To: Matt LeGrant, Zoning Administrator

Re: 100 V Street SW, Square 609 and 611

TO: Matthew Le Grant  
FROM: Norman M. Glasgow, Jr.  
DATE: May 22, 2020  
RE: 100 V Street, SW

Option 1 - Enclosed Connection at PH level, set back from Level 13 Connection

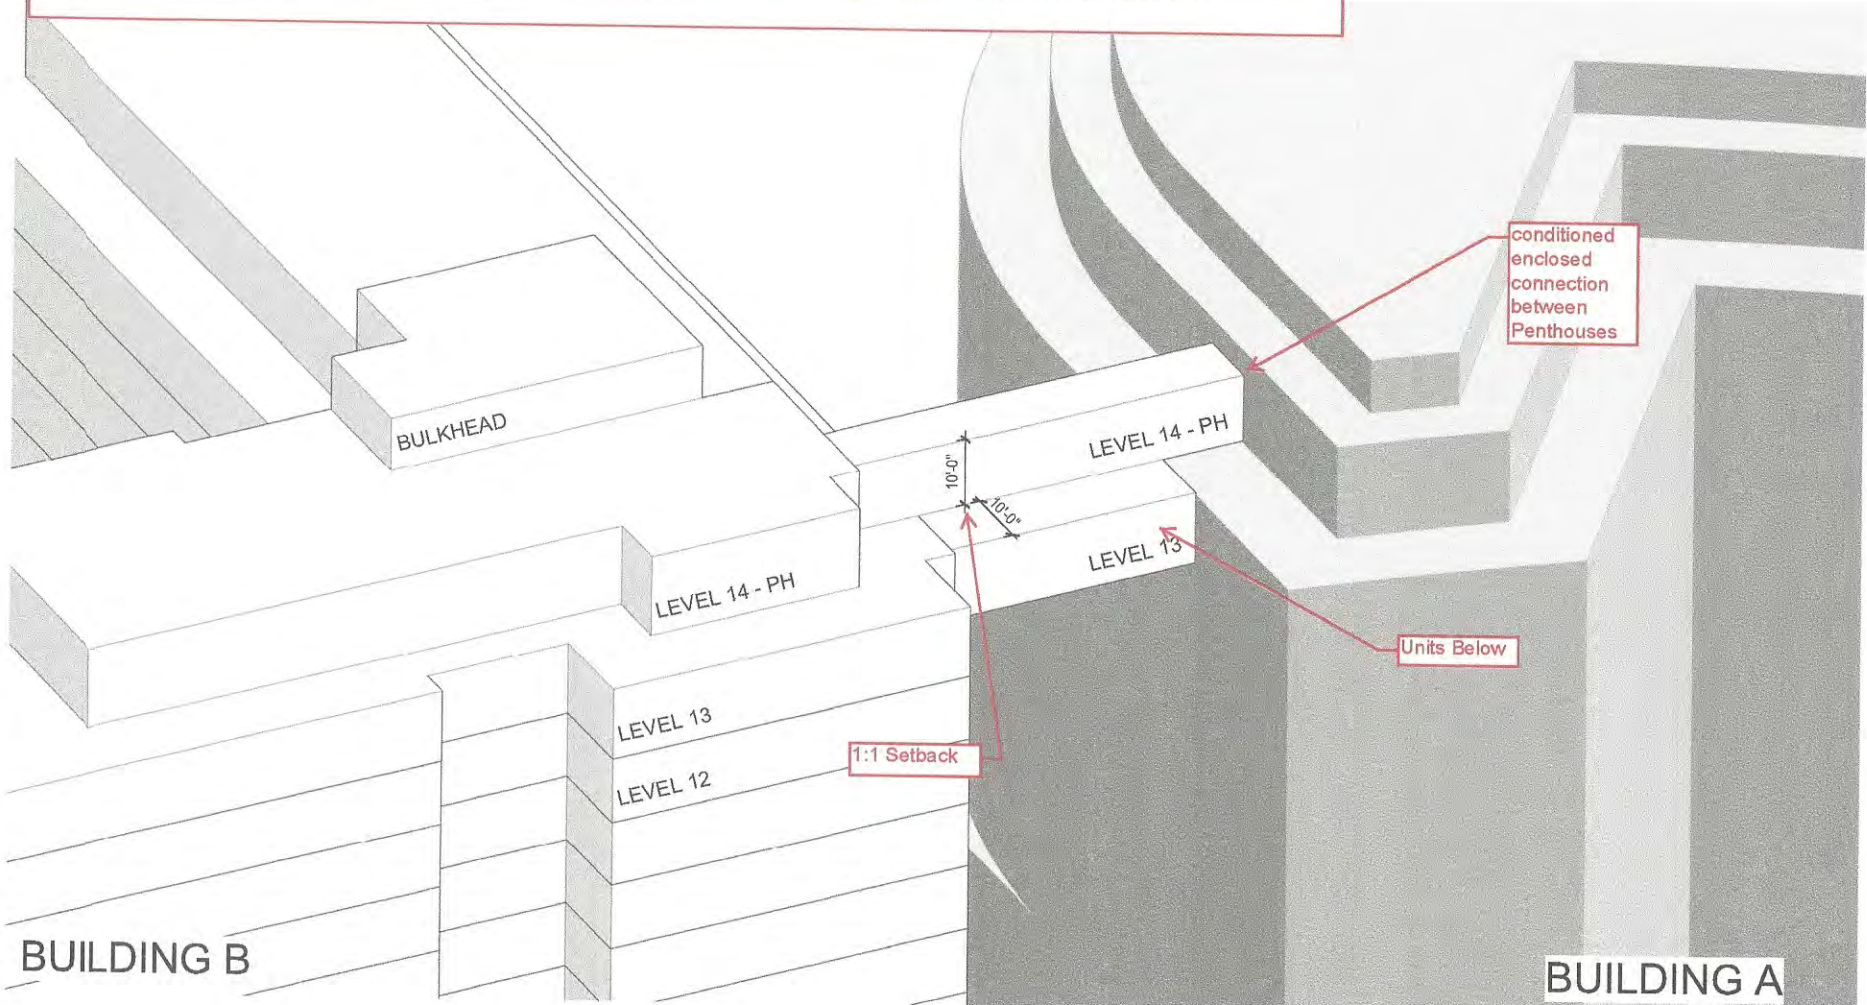
As a part of our virtual meeting of April 14, 2020, we reviewed axonometric plans and architectural sketches showing three options for connecting buildings at the upper levels of the buildings including the penthouse level and also site plan overview and massing development plans, all of which are attached (Attachment A).

After discussion as to building connection and penthouse setback regulations, you determined that any one of the three connection options as depicted and dimensioned would be in compliance with the provisions of 11-C DCMR § 1500 et seq.

# Building A-B Bridge Studies

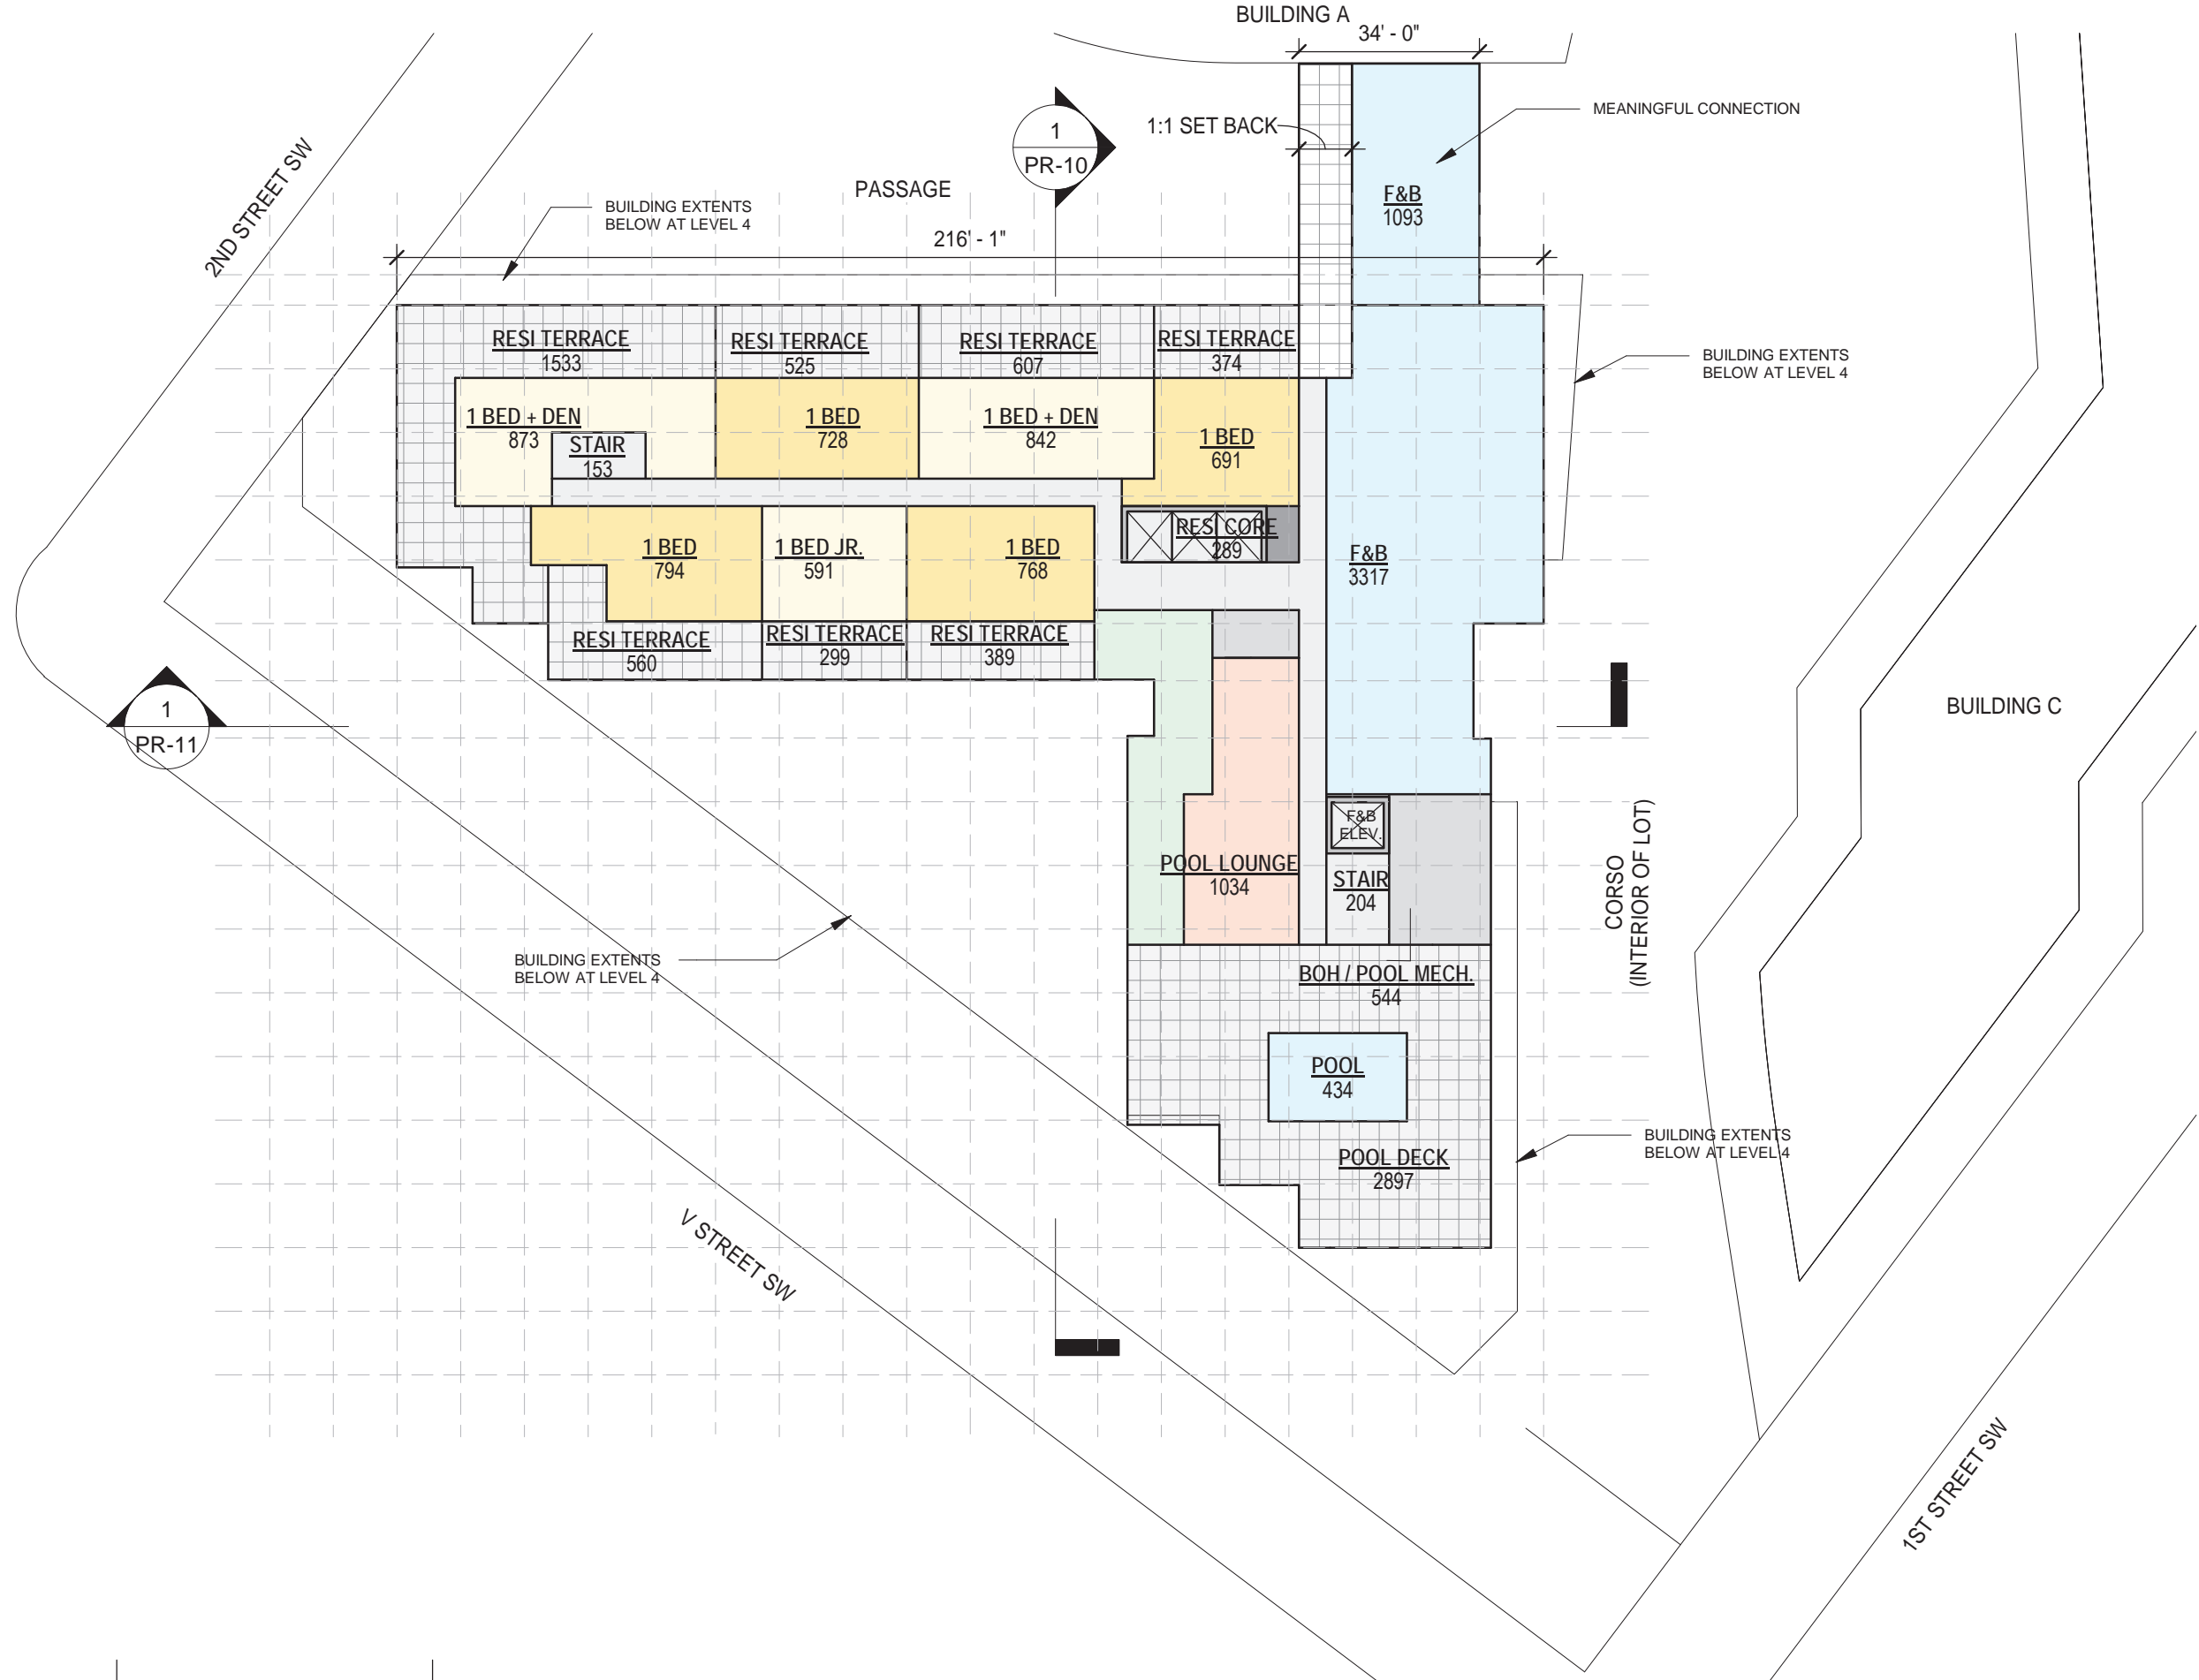
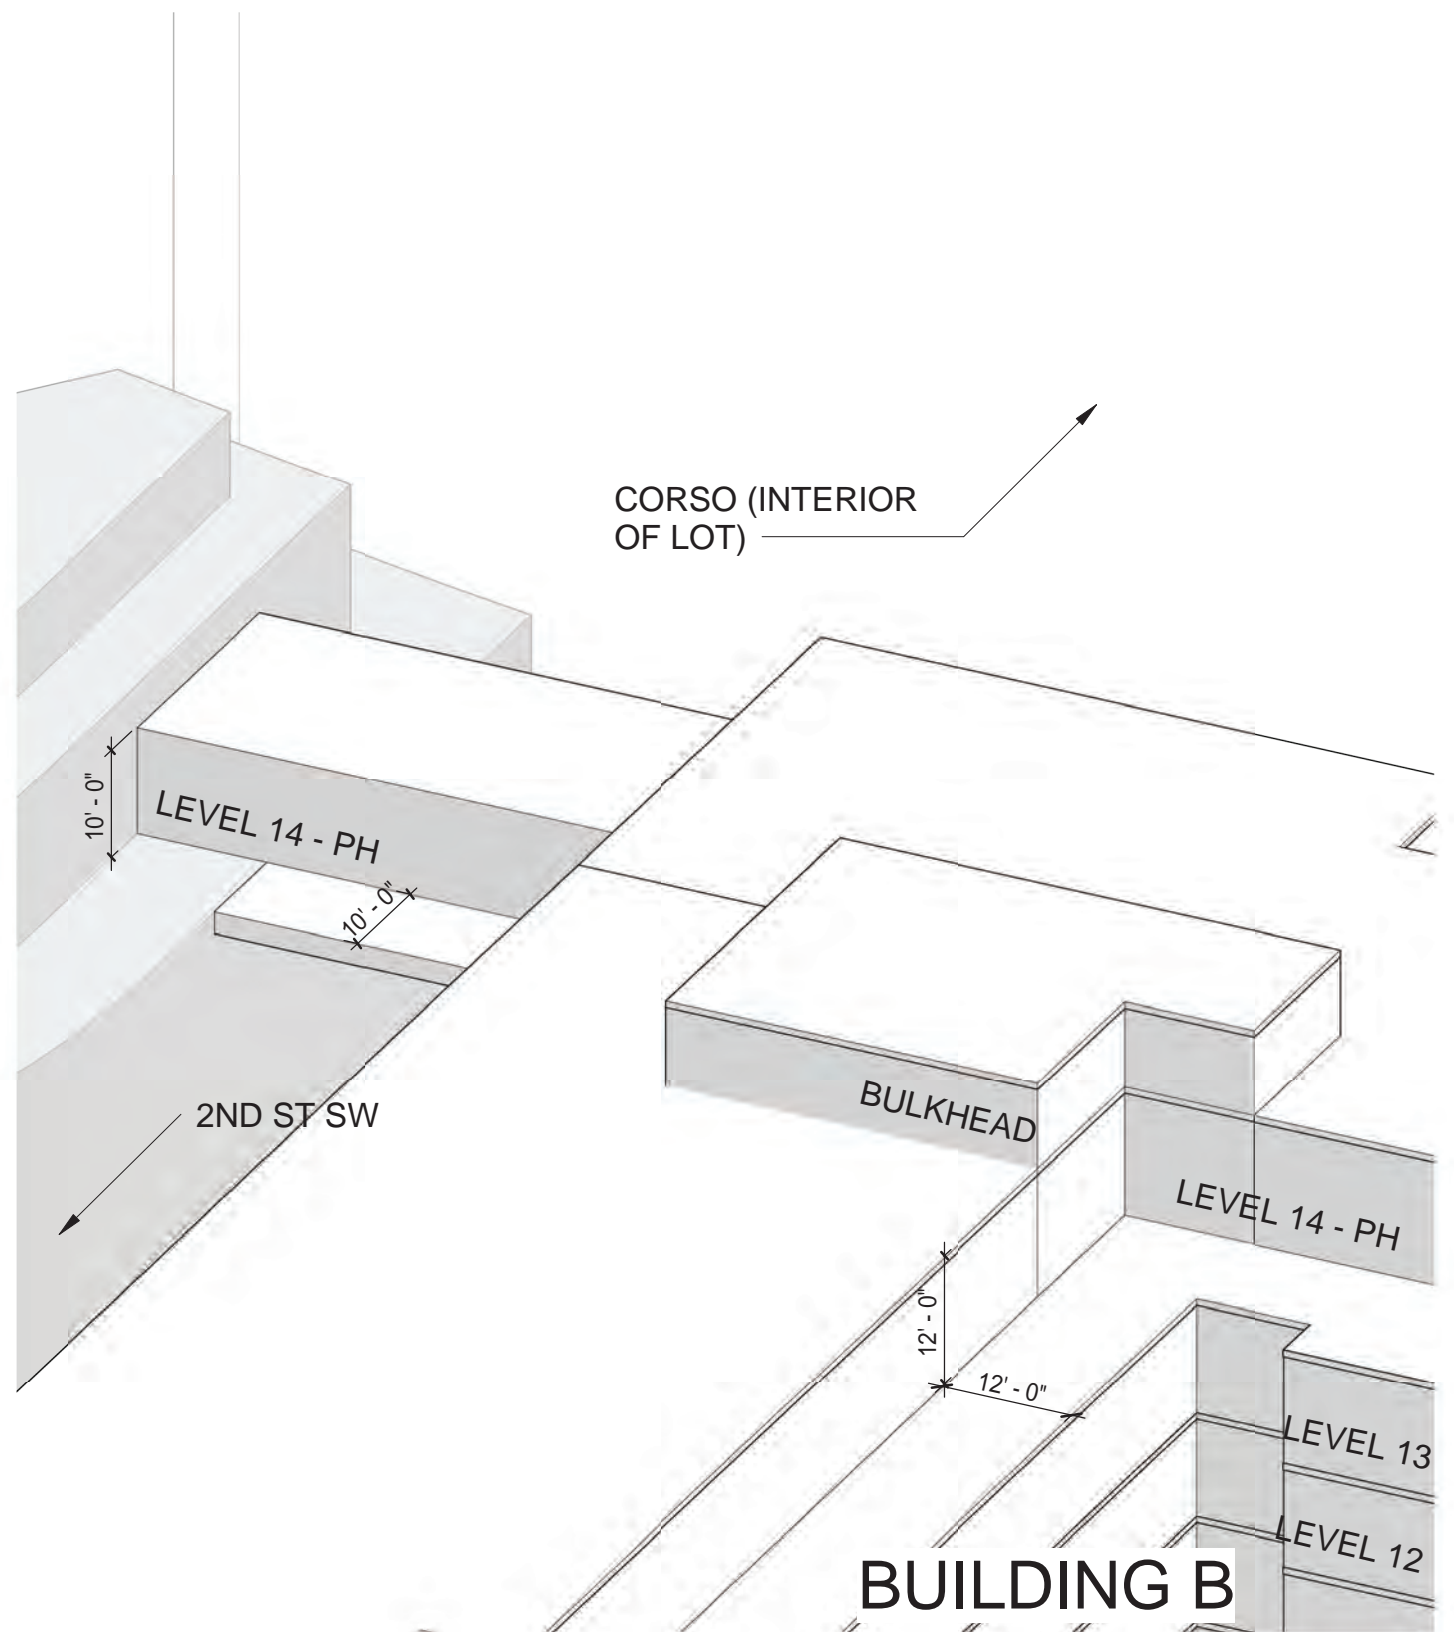
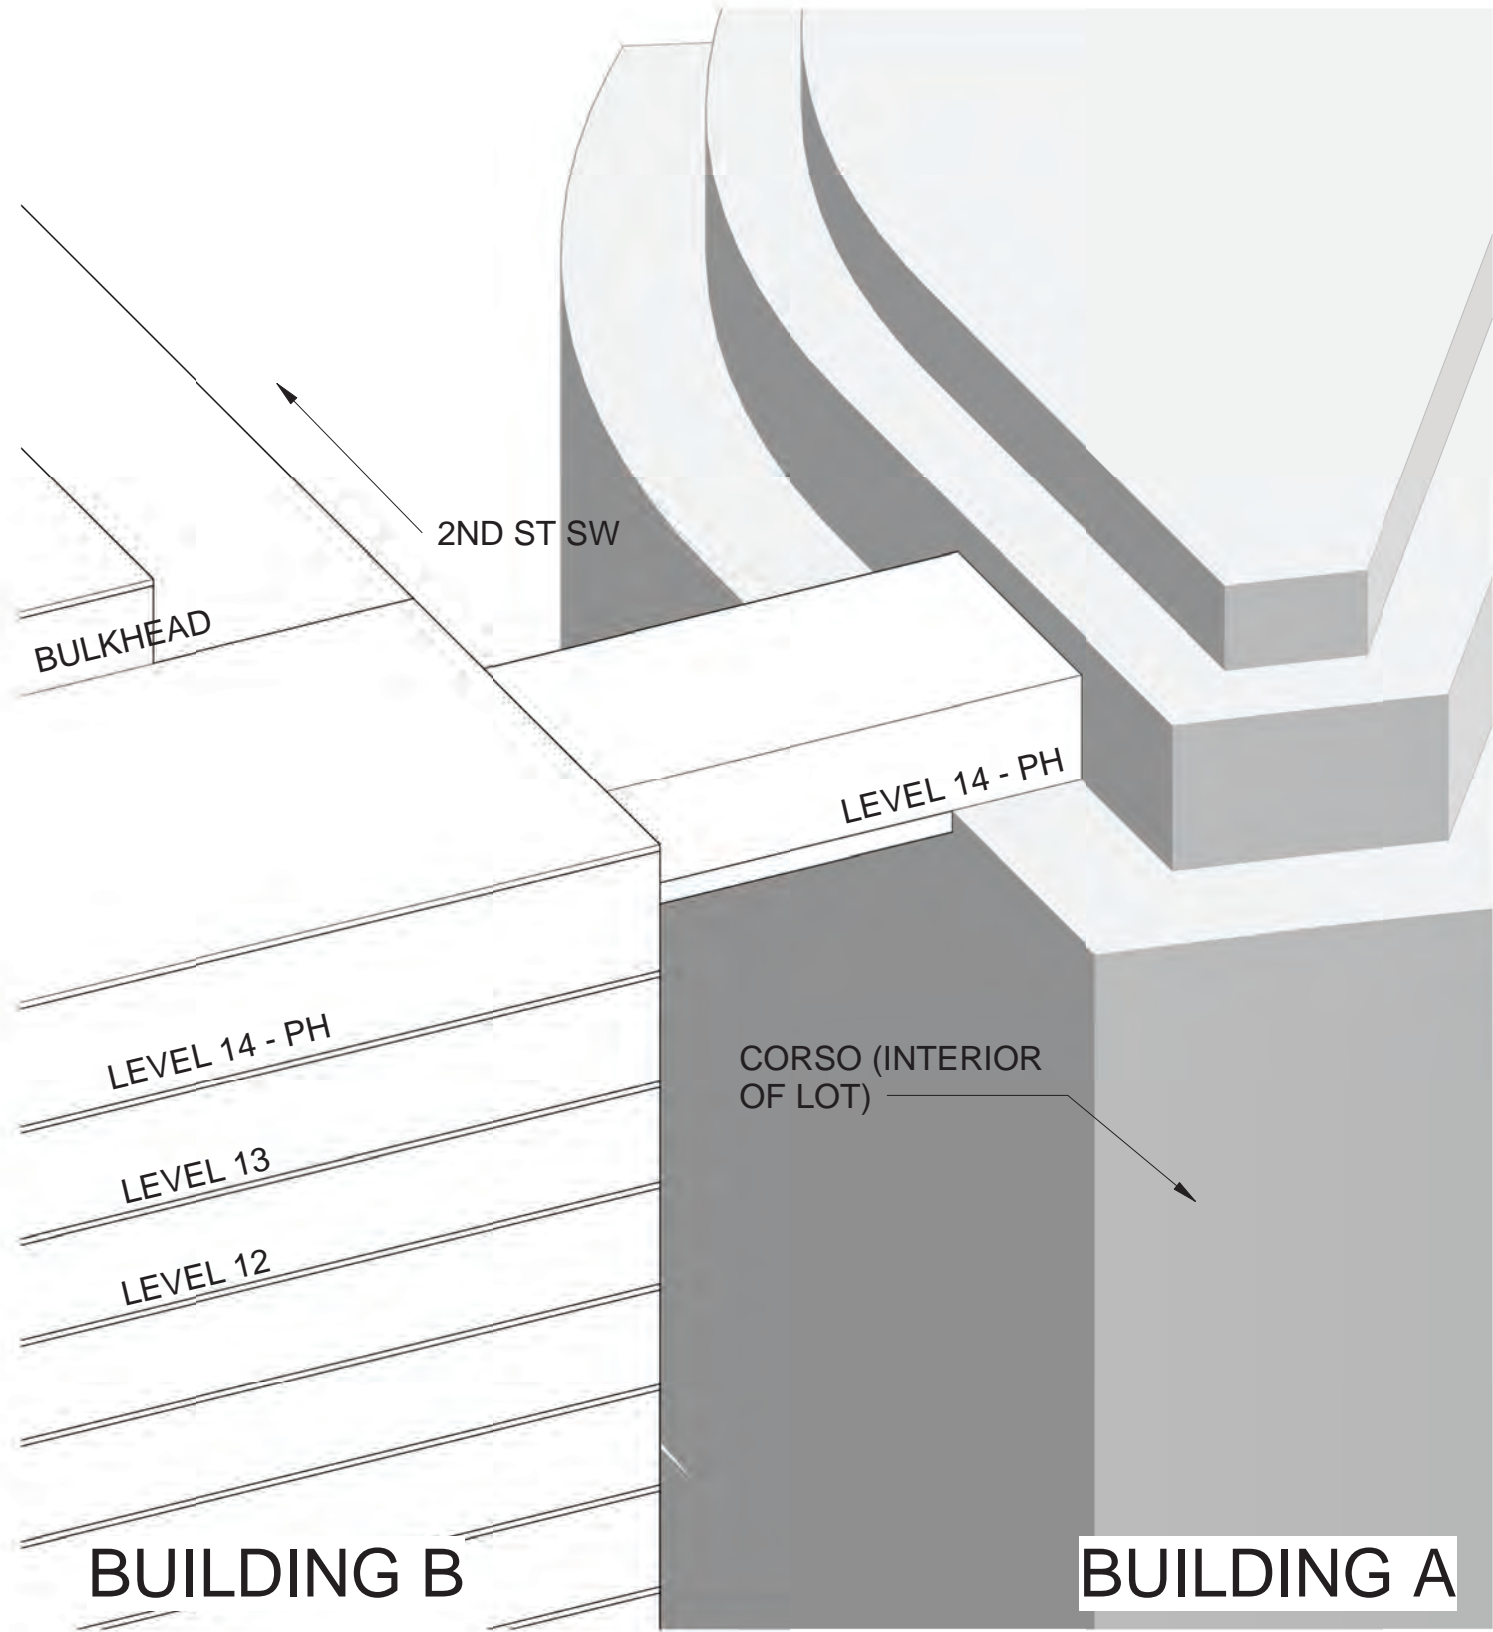
As a part of that discussion you requested, and attached hereto, are drawings (Attachment B) which show that on the interior side of the building connection and penthouse connection that there may or may not be a setback. This would be permitted since such connections on the interior facing sides of the site would constitute closed courts and not open courts. *See* Sheet Numbers 21 and 33 at the lower right-hand corner of the pages. The connection areas facing outward where the setback is required and as shown on the options one through three would be facing toward the public streets and therefore open courts.
